#### **RE – Sebastopol Solar Farm (SSD 9098) – Response to Submissions**

**Sebastopol Solar Farm proposal - SSD 9098 – additional information**

**RE: Sebastopol Solar Farm proposal - SSD 9098 - Eurolee Road proposed upgrades**

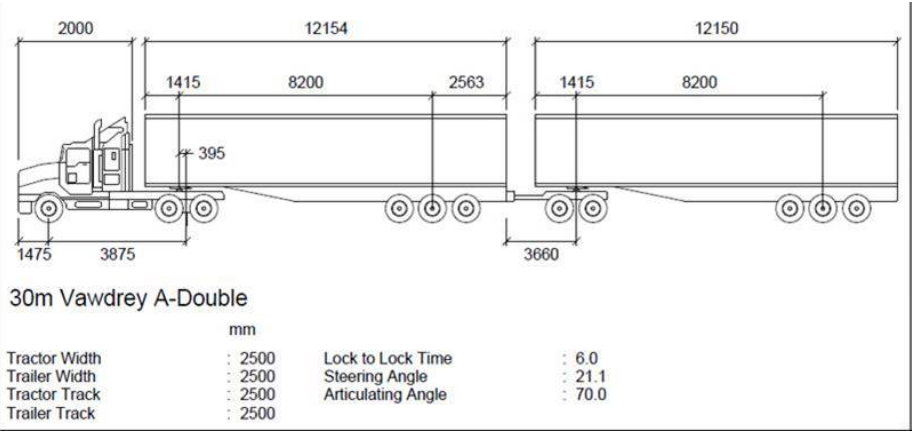
The largest heavy vehicle proposed is an A-double, up to 30m long, see dimensions below.
